MAP 1

SOUTH OF MARKET PLANNING AREAS

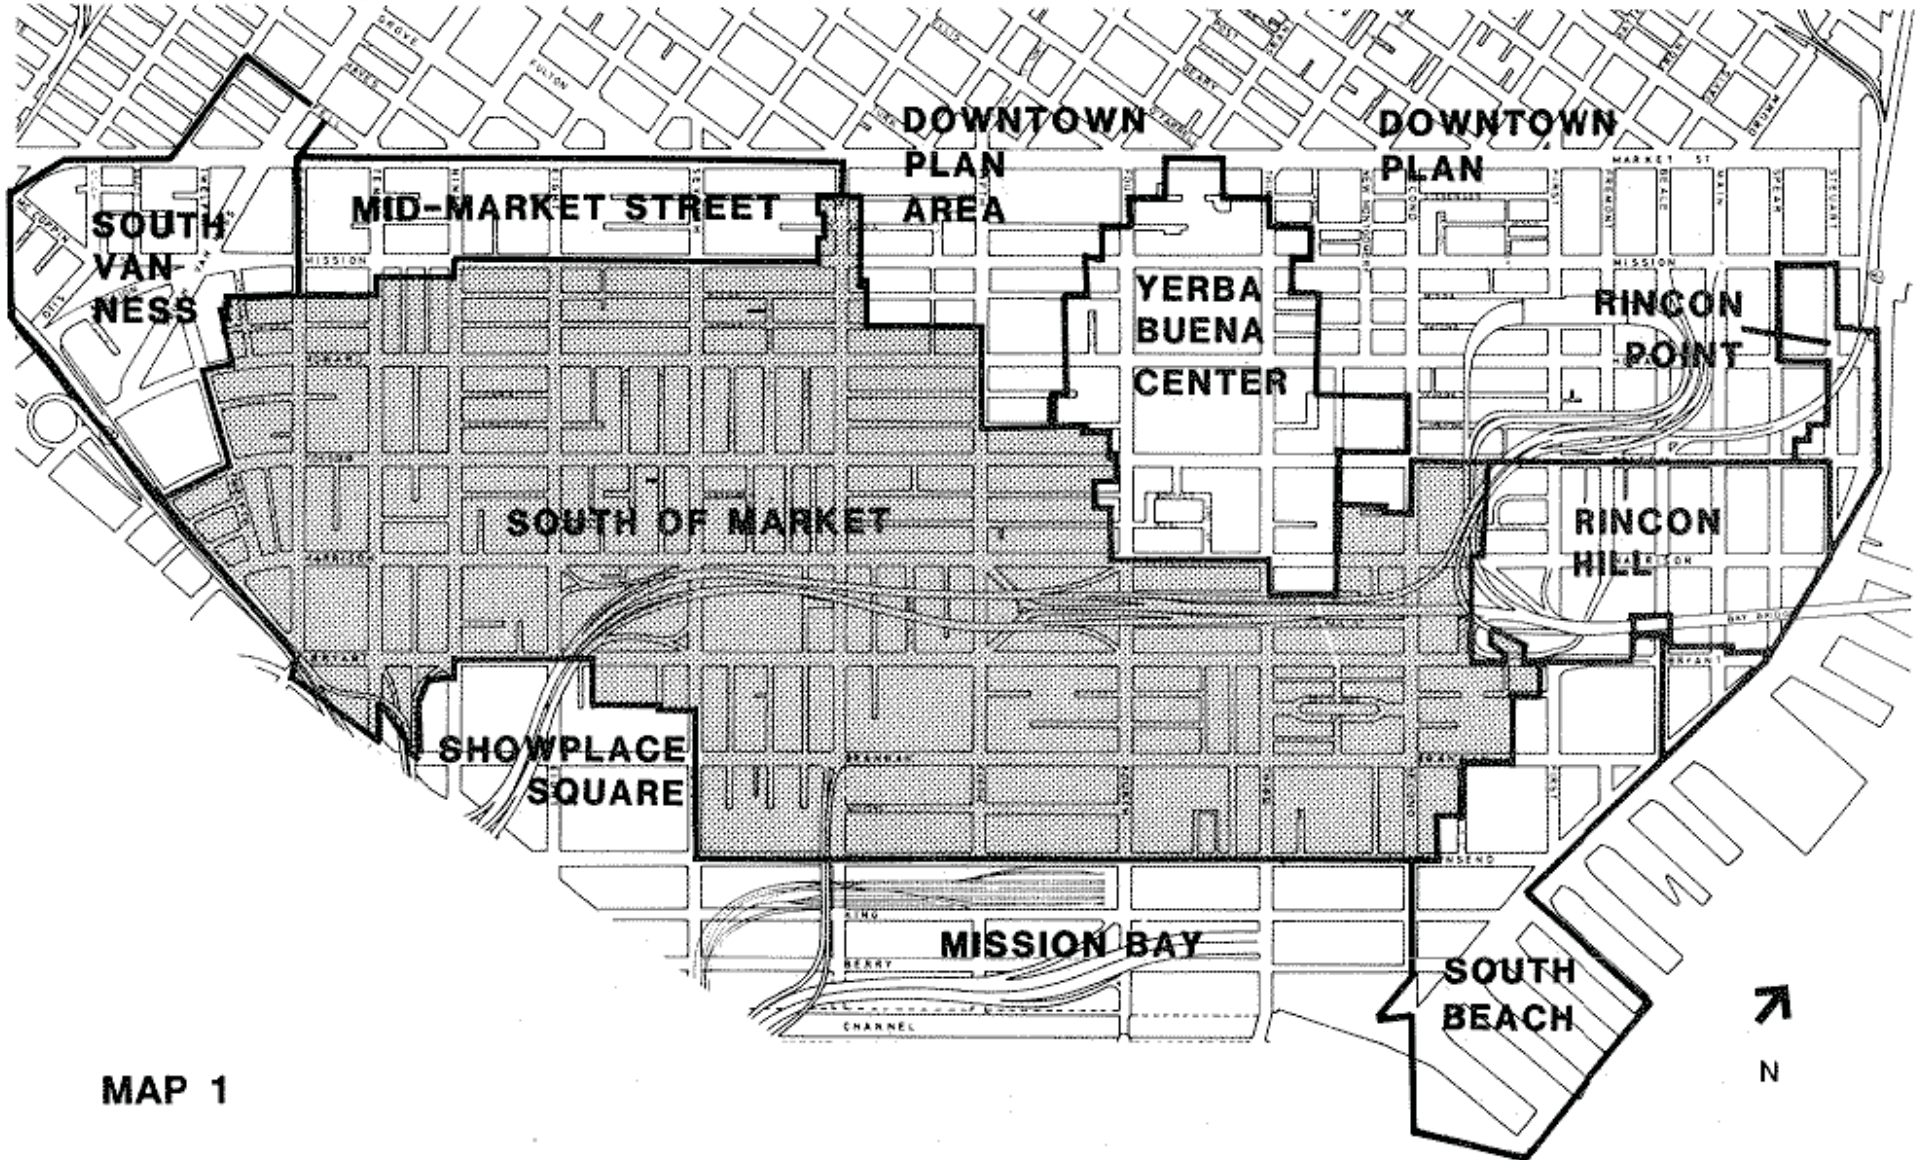
MAP TO BE EDITED

- Add East SoMa Area Plan boundaries, and change South of Market boundaries to reflect accurate plan area boundaries, to exclude East SoMa and remove Embarcadero Freeway ramps.
- Amend so that the boundaries of Rincon Hill are accurate.
